LRB-2022-04 - Review of Condition 5 on planning permission 21/01525/FLL - Formation of all weather sports pitches and access road, erection of fencing, installation of floodlighting and associated works, land 100 metres south west of Goodlyburn Primary School, Crieff Road, Perth

**PAPERS SUBMITTED
BY THE
APPLICANT**

NOTICE OF REVIEW

PLANNING DECISION NOTICE

Figure A7.1 – Barrier Mitigation required to achieve “minor” level of significance with all 3 pitches operating in both the day and evening.

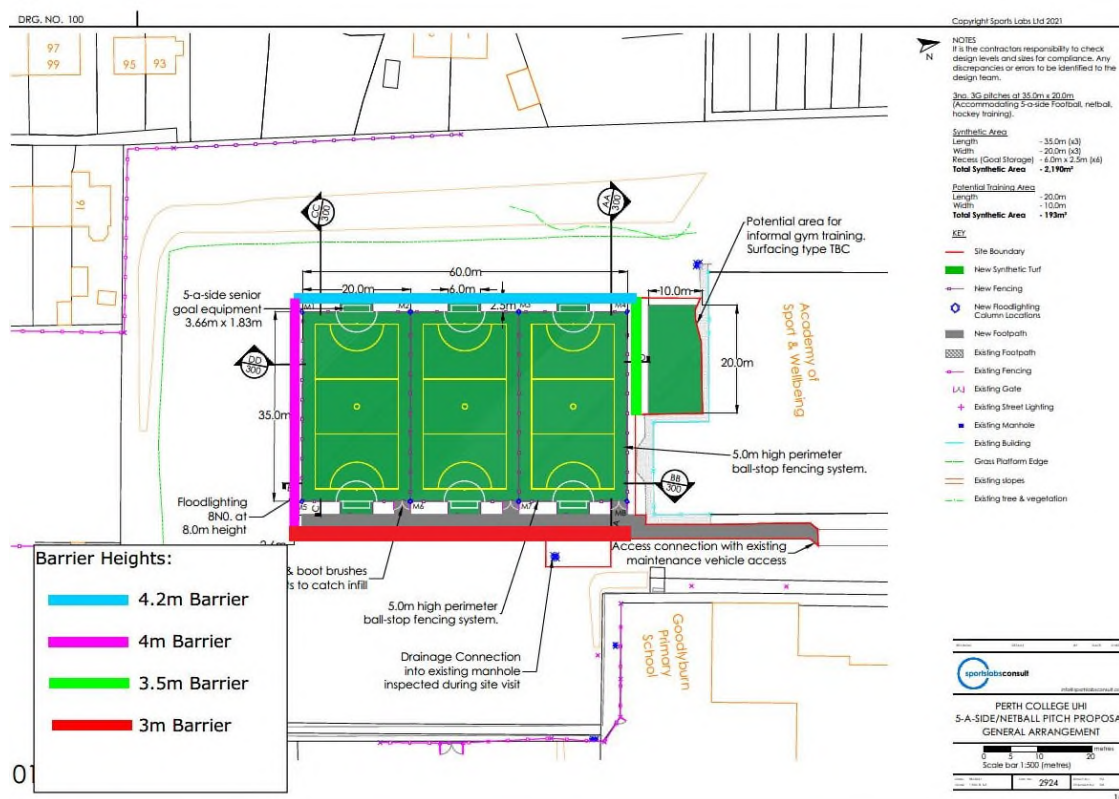
- 5 Prior to the completion or bringing into use of the development, whichever is the earlier, acoustic barriers shall be installed in line with the recommendations in the Noise Impact Assessment Report No. 7387-00-02 dated 18th November 2021 and in accordance with the layout plan in Appendix 7 of the report. Thereafter, the acoustic barriers shall be retained for the life of the development, to the satisfaction of the Council as Planning Authority.
